Automotive Silicon Errata and Data Sheet Clarifications

ATtiny212/214/412/414 Automotive

The ATtiny212/214/412/414 Automotive devices you have received conform functionally to the current device data sheet (www.microchip.com/DS40002229), except for the anomalies described in this document. The errata described in this document will likely be addressed in future revisions of the ATtiny212/214/412/414 Automotive devices.

Figure 25-1. USART Block Diagram

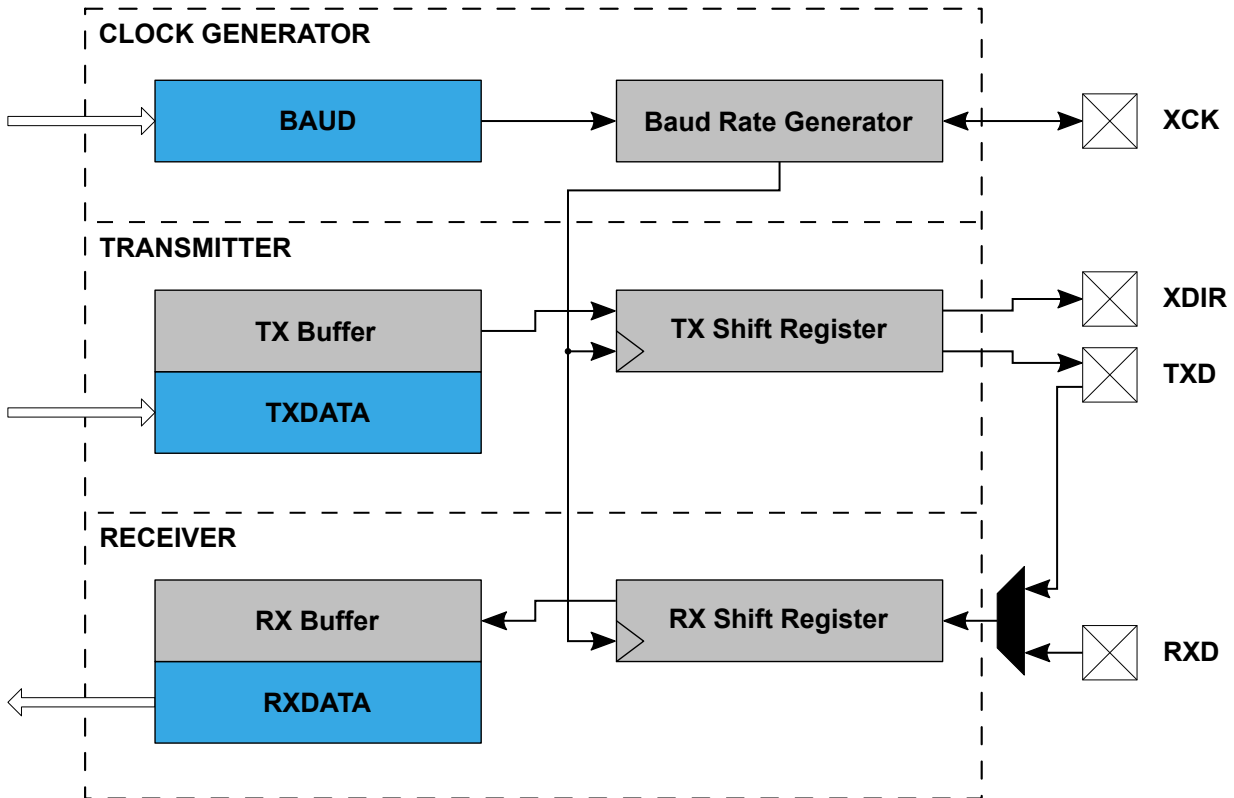
The block diagram is missing that USART TX is double-buffered from *Figure 25-1* in the data sheet. The figure below shows the added **TX Buffer**.

The transmitter consists of a **two-level** write buffer.

The data transmission is initiated by loading the **Transmit Data (USARTn.TXDATAL and USARTn.TXDATAH)** registers with the data to be sent. The data in the **Transmit Data registers are moved to the TX Buffer** once emptied and then to the Shift register once it is empty and ready to send a new frame.

Figure 3-2. 8-Pin SOIC

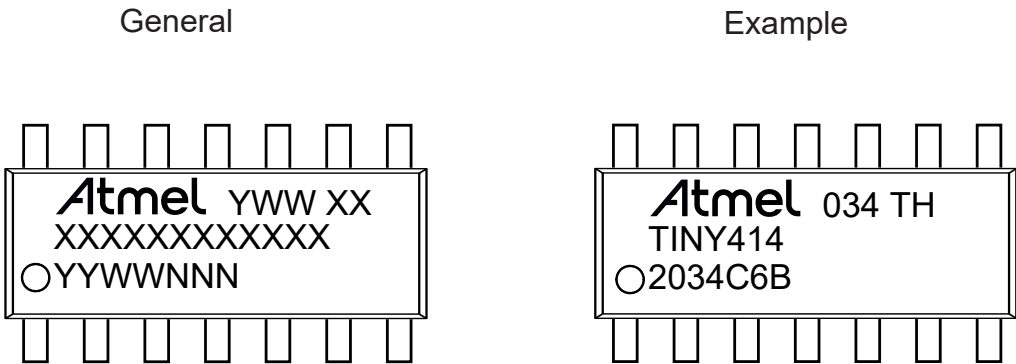
Package marking information is missing in the data sheet. This section contains all package marking information for:
